**RE: Dreamstyle Warehouse, 1525 Renaissance Center
Grading and Drainage Plan
Engineer's Stamp Date 6-19-2015 (File: F16-D051A)**

**RE: DREAMSTYLE WAREHOUSE
1525 RENAISSANCE CENTER
GRADING AND DRAINAGE PLAN (F16-D051A)**

<div>ENGINEER'S SEAL</div> <div></div> <div>RONALD R. BOHANNAN P.E. #7868</div>	TRACT 9A RENAISSANCE CENTER GRADING AND DRAINAGE PLAN <div>TIERRA WEST, LLC 5571 MIDWAY PARK PLACE NE ALBUQUERQUE, NM 87109 (505) 858-3100 www.tierrawestllc.com</div>	DRAWN BY BJF
		DATE 06/10/15
		2015009-GRB
		SHEET # D2
		JOB # 2015009

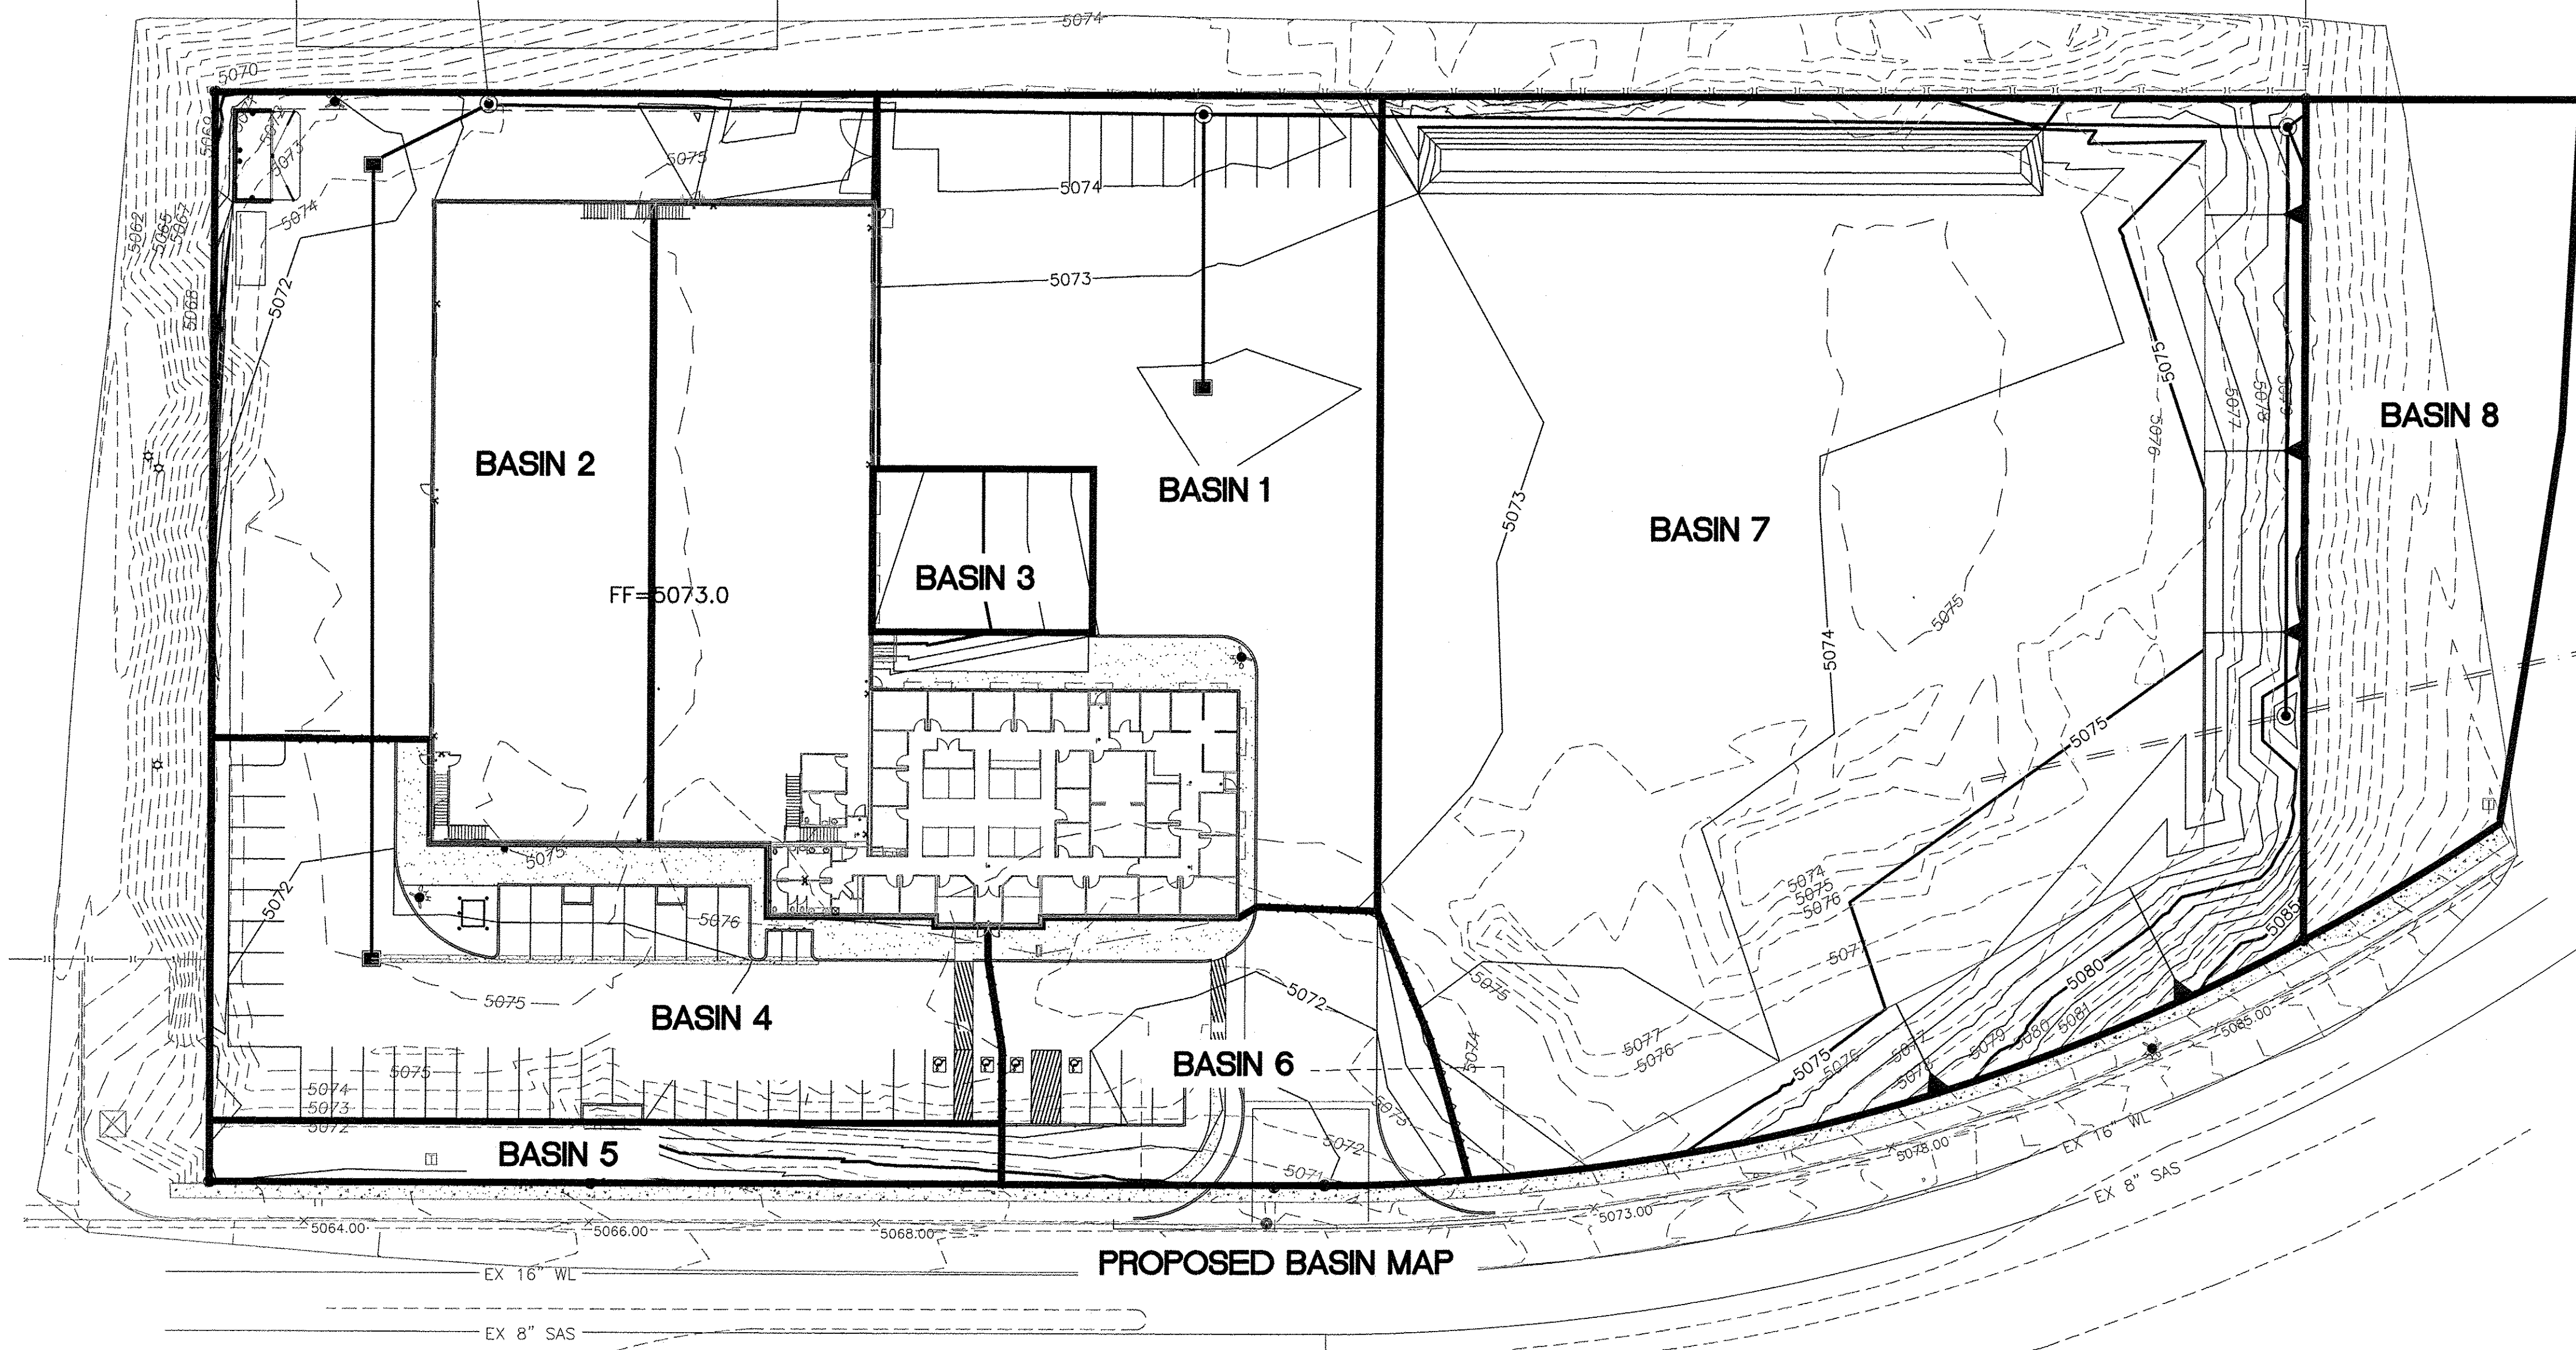
- 1) The first flush from the new building site must be retained. The off-site pond ("Pond 5") that is currently proposed to handle first flush does not meet the requirements because it is discharging the first flush at a controlled rate in lieu of retaining it. In addition to options mentioned from the last letter, another option may be to locate the pond just northeast of the new building within the area where the paved parking is shown and relocate the paved parking elsewhere. Along with the proposed change, state how first flush is to be managed on the grading and drainage plan in along with labeled required volumes.

- 1) Provide plat for Tract 9A that may show a private easement for the proposed storm drain that routes off-site flows through site. If one is not already provided, a paper easement is required.
- 2) In order to control the flow to allowable discharge of 0.66 cfs to the street, revise grades at the entrance.
- 3) The Type "D" drop inlet upstream of Pipe 3 does not show the capacity to handle the amount of flow listed for Pipe 3. Label curb along the west edge and other parking areas if applicable, and have a general note stating that the listed elevations are at the flowline as applicable. (There is a discrepancy between the spot elevation of 5071.40 and the grate elevation of 5071.25 near the northwest corner of the new building where the 5071.25 elevation appears to provide sufficient head to capture the required flow.)

1. The First Flush Pond area must retain the impervious area of the currently proposed building at a depth of 0.34" and not be intended to only allow drainage from future impervious development on Basin 7. Show drainage from new building construction to a first flush pond area instead of directly draining it into the new storm drain system. Based on the site plan layout, some options may be to provide an area within small pervious area at the southwest corner of the building while maintaining the required minimum distance away from the building, providing a roof drain to directly tie into the currently proposed first flush pond location, and utilizing the pervious area south of the proposed parking lot. Show all roof drains for new building.

2. Label existing contours, particularly the major ones. Also provide new contours for the site along the 3: 1 slopes.
The contours are now labeled and proposed contours were added to the plan.
3. Show existing and new contour elevations around the perimeter of the site to show how new grading ties into existing and does not adversely impact adjacent sites. Also include existing spot elevations along Renaissance Blvd, and label Renaissance Blvd. on the plan view.

4. Reference that the 9.79 cfs of off-site flow came from the Master Drainage Plan. In addition to the 9.79 cfs entering the site from the storm drain, address how much off-site flow is coming from the sloped area to the east of the site and show this off-site basin area in the calculations. Call out existing pipe size that is conveying the 9.79 cfs. With this addition, maintain an overall site discharge of below 24.97 cfs to Pond 5.
Basin 8 was added to capture the amount of flow from the sloped area and that flow was added to the calculations. The total discharge to Pond #5 is 24.89 cfs which is still below the allowable 24.97 cfs.

5. For the entryway into the site, call out COA Standard Dwgs. 2426 and 2420 as applicable.
The standard drawing numbers for the entrance were added to the plan.

6. For connection of dock drain into the main storm drain, call out a tee connection and invert elevation.
A tee connection is now called out on the plan.

7. Correct spot elevation showing "50730.0" at the corner of the building to correct elevation.
The spot elevation was corrected.
8. If 0.66 cfs is allowed to be discharged into the street, the allowable flow should be met unless it can be shown that the street and the downstream storm drain system in Renaissance that will be capturing this flow can handle the additional 0.96 cfs.
The total amount of discharge to the street is 1.0 cfs which is slightly higher than the 0.66 cfs proposed in the previous drainage study. Since an amount greater to this flow and volume is captured in the proposed first flush pond, the downstream capacity is actually increased and can easily handle the additional 0.34 cfs discharged to the street.

9. Show capacity calculations for on-site inlets.
Inlet capacity calculations were added to the plan.

The proposed impervious area drains to a pond that has a restricted flow allowing that water to pond for a long period of time. When the water is discharged from Pond #5 it is then conveyed to the regional pond along Montano Road. The discharge from that pond is controlled by a manual valve thus effectively creating another first flush pond.

This type of drainage system is consistent with Section 14-5-2-6(H) which states first flush systems shall be used where practicable except, "where appropriate public or private drainage facilities are available 'offsite' and will be used in a manner consistent with the goals of Section 14-5-2-1." We believe this design meets those requirements.

Existing spot elevations along Renaissance Blvd. were added as were the proposed contours tying to the existing contours.
